FREDERICK COUNTY PLANNING COMMISSION

TITLE: Margie's View, Lots 1 and 2

FILE NUMBER: M-3032, AP 19195 (APFO N/A, FRO 19196)

REQUEST: Driveway Entrance Spacing Modification

COMBINED PRELIMINARY/FINAL PLAT

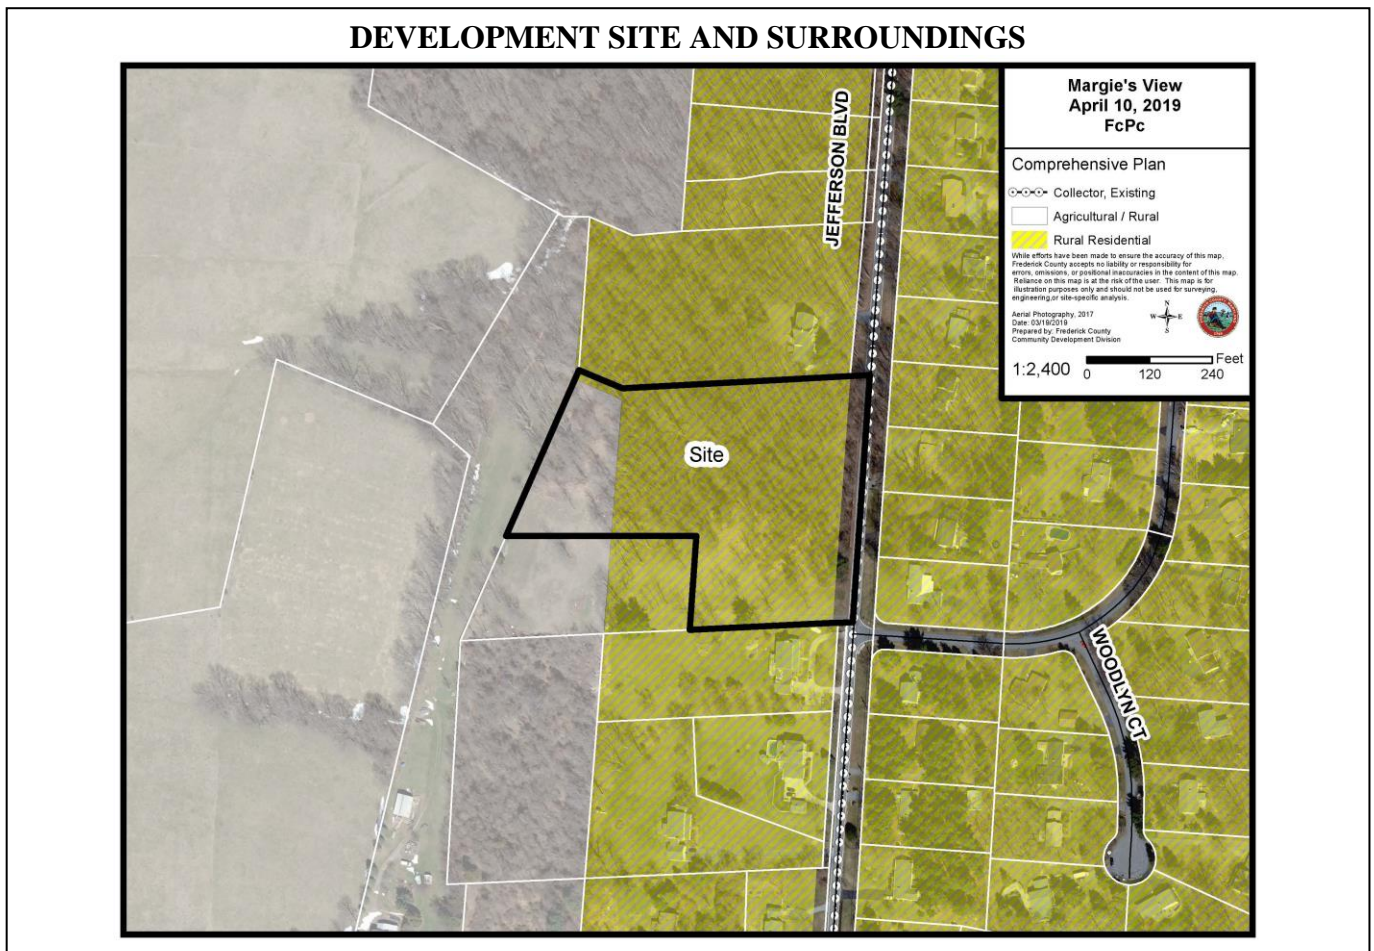
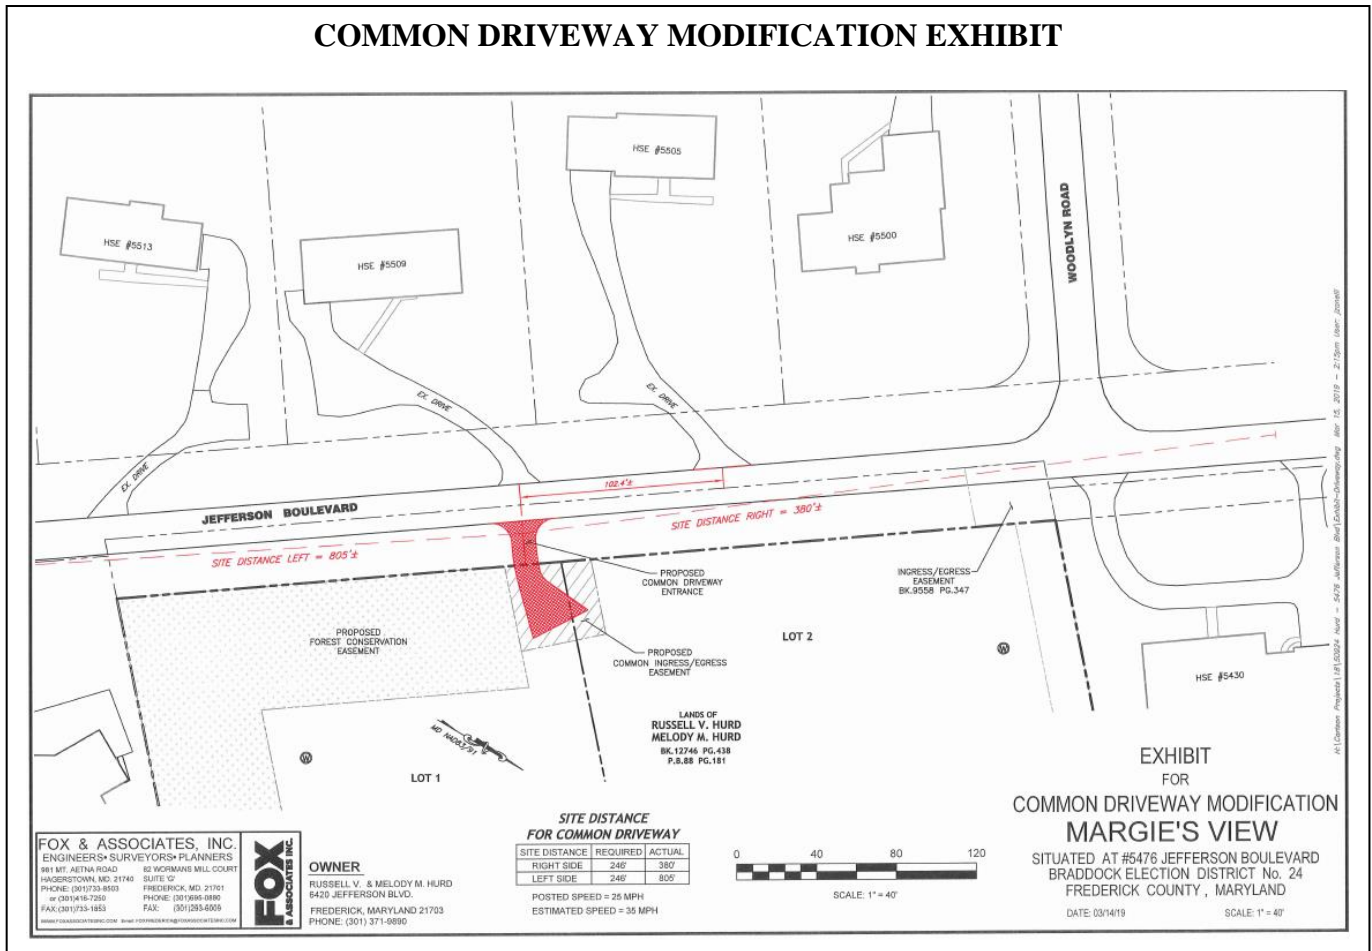
The proposed common driveway entrance accessing Jefferson Boulevard will serve proposed Lots 1 and 2. Jefferson Boulevard is a Collector classified roadway (60' r/w) that requires an FcPc modification when less than 150 feet separates a new common entrance from the nearest existing residential entrance (see first entry in Table 4 of Exhibit 2). The proposed common entrance location is 102 feet to the nearest existing driveway to the north and approximately 207 feet from the existing driveway to the south. The southern separation is adequate for staff approval, but the 102 feet of separation to the north requires FcPc approval for the application to move forward.

The proposed new entrance location exceeds the minimum sight distance requirement for a safe location for ingress/egress.

Because the Applicants have demonstrated adequate sight distance for the proposed driveway location and the location is consistent with driveway separation in the neighborhood, staff supports the approval of this modification for this application (M-3032, AP 19195) subject to the following conditions:

1. The Applicants shall comply with all Staff and agency comments through the completion of the plan.
2. The Applicant shall construct a common driveway to facilitate access to each lot prior to lot recordation. The area of driveway extending into Lot 2 as shown on the plat shall be extended further into lot 2 to facilitate the required access.
